<b>Project:</b>	<b>Pier A Plaza Construction Services</b>	<b>Date:</b>	<b>March 28, 2013</b>
<b>Designer:</b>	<b>Arup</b>	<b>RE:</b>	<b>Addendum #01</b>
		<b># of Pages:</b>	<b>(2 pages)</b>

The following revisions and/or clarifications are to be made to the proposal documents for "Pier A Plaza Construction Services". They are a result of issues discussed at the pre-proposal conference held on March 20, 2013 and any questions received by close of business on March 27, 2013.

SK-RFI-2-001

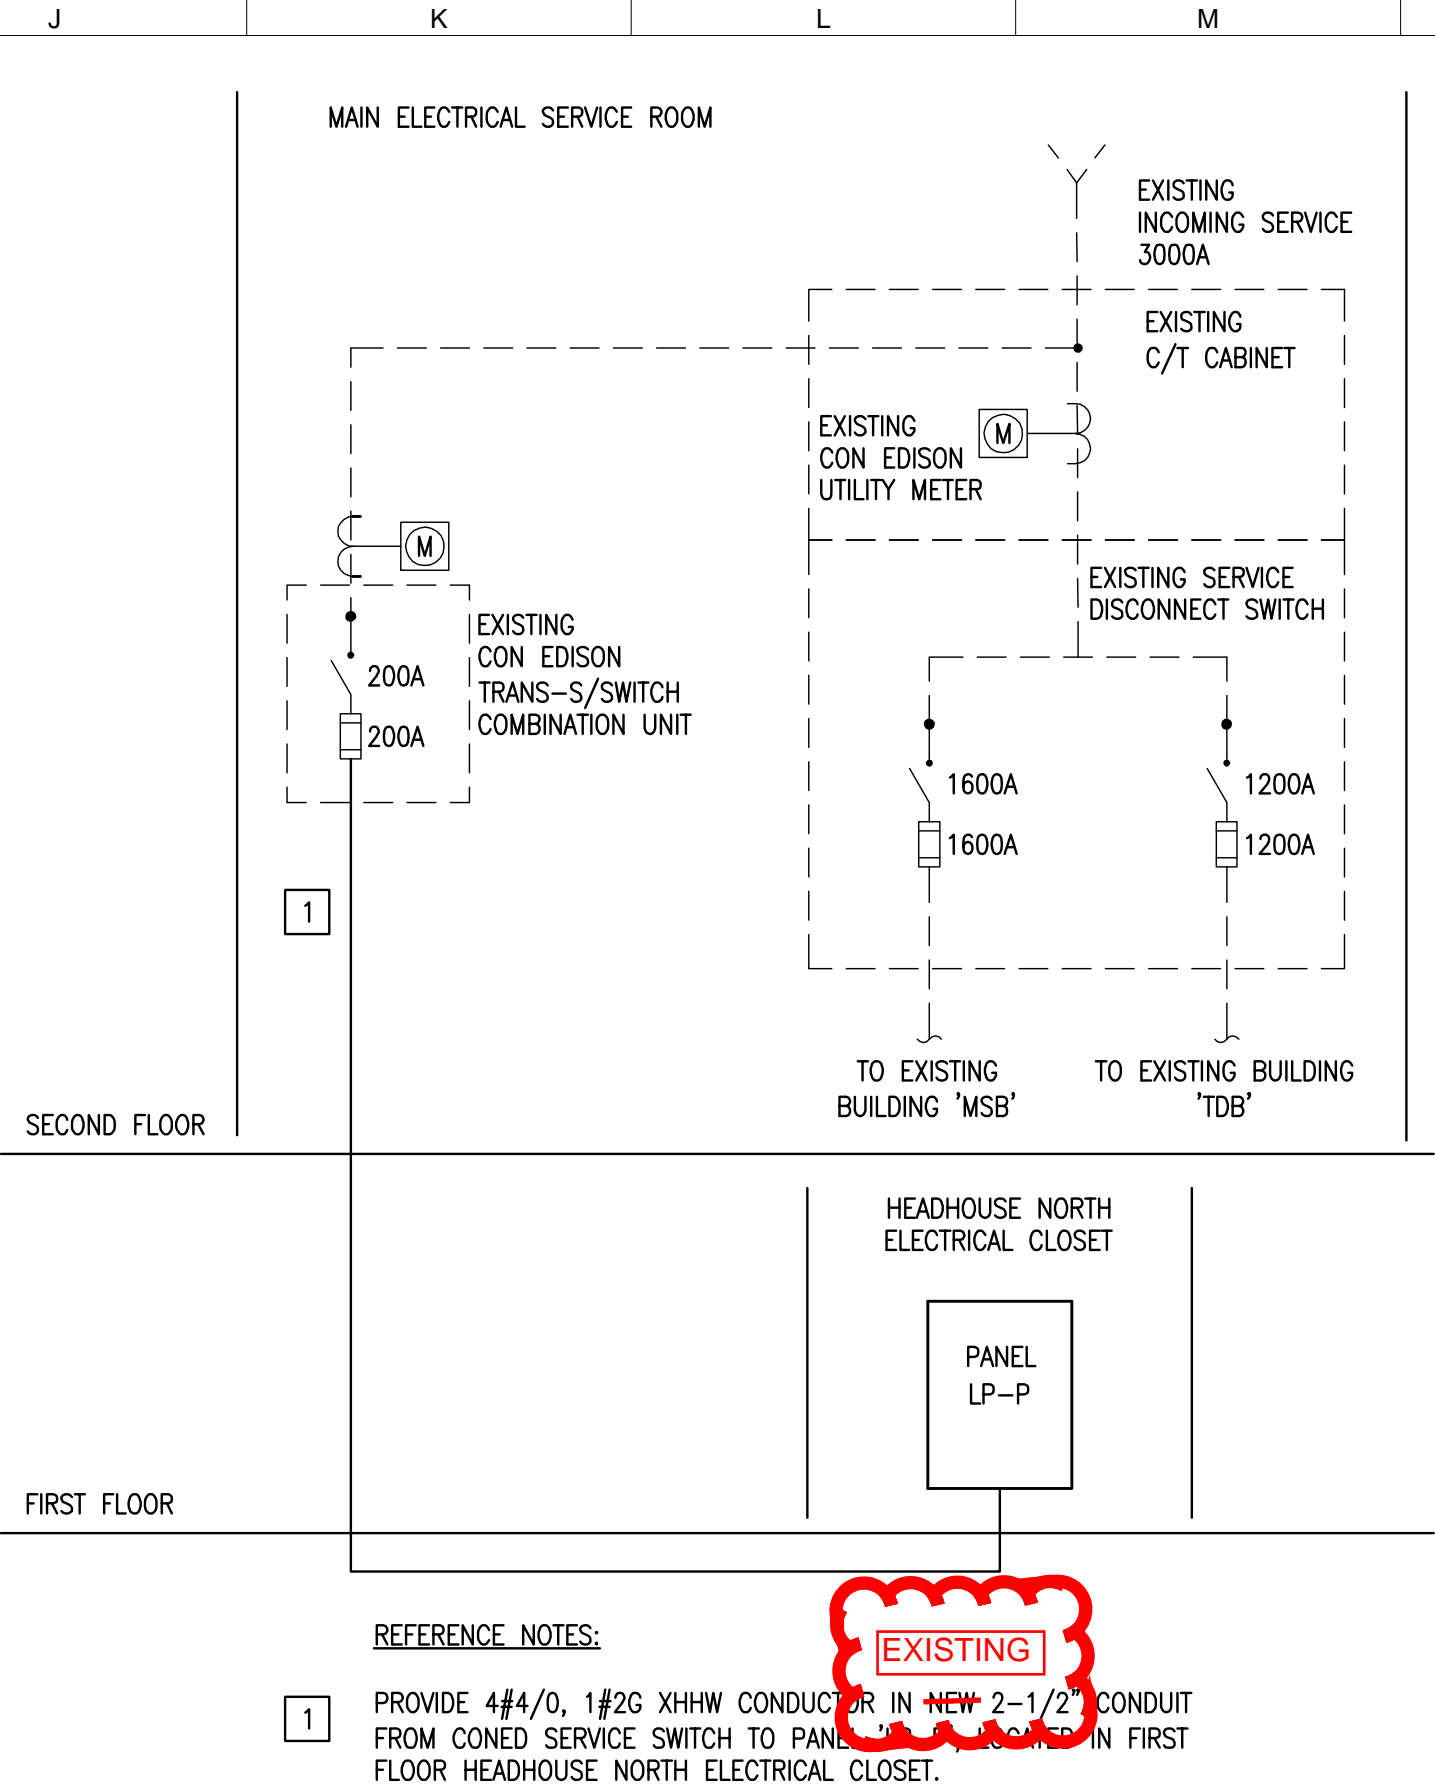
8. The panel schedule on drawing E-311 conflicts with the circuitry designations on drawing E-313 please clarify which takes precedence and how many lighting circuits are required.

9. On drawing E-311 note #1 on the "Electrical Single Line Diagram" states to provide 4#4/O, 1#2G in NEW 2-1/2" conduit from ConEd service switch to panel "LP-P". However drawing E-312 shows the floor plan of the conduit run from the ConEd service switch to panel "LP-P" and note #1 on that drawing says it is existing. Please clarify

*Answer: The 50A receptacles should be supplied by 3-phase breakers from panel LP-P. See attached sketch SK-RFI-2-001 and SK-RFI-2-002.*

*Answer: The 2-1/2" conduit is existing, the conductors (4#4/O, 1#2 G.) are new. See attached sketch SK-RFI-2-001 and SK-RFI-2-002.*
